Case No. 12-006PF Herb & Melba Parker Addition

Proposed Plat

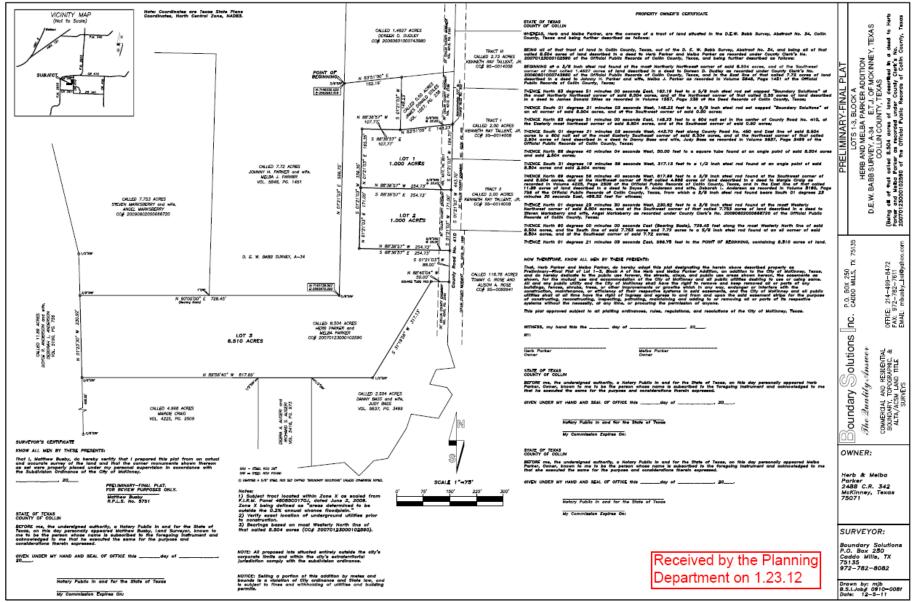
- 1. A variance to Section 142-105 of the Subdivision Ordinance waiving the requirement to dedicate right-of-way for public rights-of-way.
- 2. A variance to Section 142-105 of the Subdivision Ordinance waiving the requirement to construct public streets including the associated street lighting and sidewalks adjacent to the subject property.
- 3. A variance to Section 142-105 of the Subdivision Ordinance waiving the requirement to dedicate easements for public utilities (water, sanitary sewer, and storm sewer) and drainage.
- 4. A variance to Section 142-105 of the Subdivision Ordinance waiving the requirement to construct sanitary sewer and water lines to the subject property and extend them to the adjacent upstream property.

- 5. A variance to Section 142-105 of the Subdivision Ordinance allowing the use of individual septic systems.
- 6. A variance to Section 142-9(22) of the Subdivision Ordinance waiving the requirement that lots utilizing individual septic systems be at least 1.5 acres in size.
- 7. A variance to the Storm Water Management Ordinance waiving the requirement to collect drainage in an underground storm water system.
- 8. A variance to the Storm Water Management Ordinance prohibiting lot to lot drainage.
- A variance to the 2006 Edition of the International Fire Code, including local amendments, waiving the requirement that fire hydrants and minimum fire flows be provided.

Staff recommends denial of the proposed preliminaryfinal plat due to a lack of conformance with the Subdivision Ordinance, International Fire Code, and Comprehensive Plan.
